ACCESSION NBR: 7904110247 DOC. DATE: 79/03/29 NOTARIZED: NO
 FACIL: 50-269 OCONEE NUCLEAR STATION, UNIT 1, DUKE POWER CO.
 50-270 OCONEE NUCLEAR STATION, UNIT 2, DUKE POWER CO.
 50-287 OCONEE NUCLEAR STATION, UNIT 3, DUKE POWER CO.

SUBJECT: FORWARDS LICENSE AMEND INCORPORATING RADIOLOGICAL EFFLUENT
 SPECS INTO TECH SPECS. OFFSITE DOSE CALCULATION MANUAL ENCL.

Subject: Oconee Nuclear Station
Docket Nos. 50-269, -270, -287

OCONEE NUCLEAR STATION
PROPOSED TECHNICAL SPECIFICATION REVISION

Figure 3.9-1

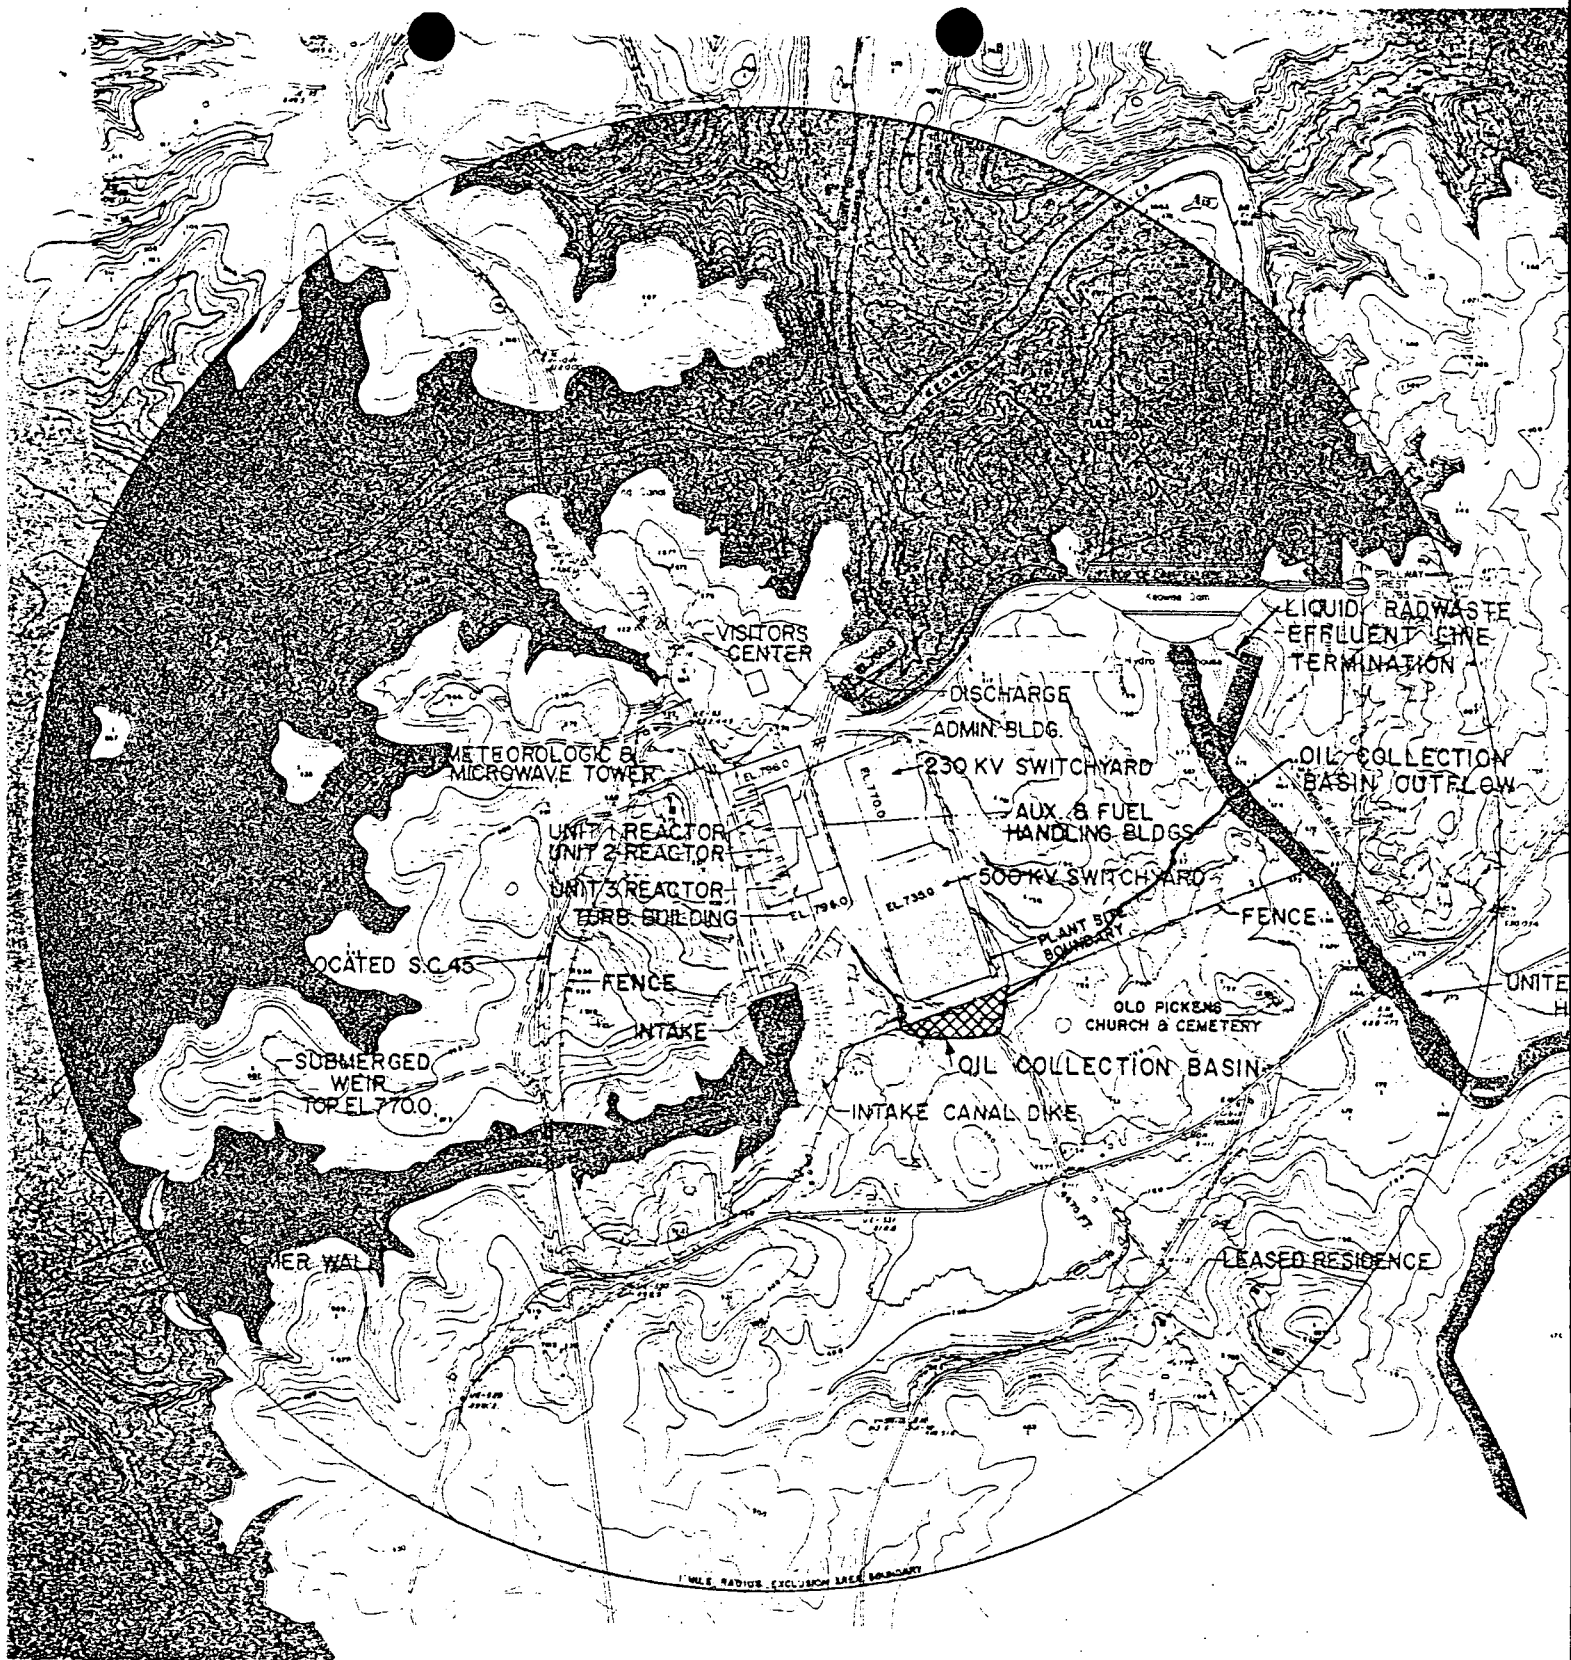
- a. The concentration of radioactive material released at anytime from the site to unrestricted areas (denoted in Figure 3.9-1) shall be limited to the concentration specified in 10 CFR Part 20, Appendix B, Table II, Column 2 for radionuclides other than dissolved or entrained noble gases. For dissolved or entrained noble gases the concentration shall be limited to 2×10^4 $\mu\text{Ci/ml}$ total activity.
- b. If the concentration of radioactive material released from the site to unrestricted areas exceed the above limits, promptly restore concentration to within the above limits and notify the regional NRC Office of Inspection and Enforcement of the occurrence.
- c. The concentration of radioactive material in liquid effluents released from the site shall be monitored in accordance with Table 4.1-4.

- a. The instantaneous dose rate at the exclusion area boundary (Figure 3.9-1) due to radioactive materials released in gaseous effluents from the site shall be limited to the following values:
 1. The dose rate limit for noble gases shall be
$$\leq 500 \text{ mrem/yr to the total body}$$
$$\leq 3000 \text{ mrem/yr to the skin and;}$$
 2. The dose rate limit for all radioiodines and for all radioactive materials in particulate form and radionuclides other than noble gases with half-lives greater than 8 days shall be $\leq 1500 \text{ mrem/yr to any organ.}$
- b. If the dose rate exceeds the above limits, promptly decrease the release rate to within the above limits and notify the regional NRC office of Inspection and Enforcement of the occurrence.
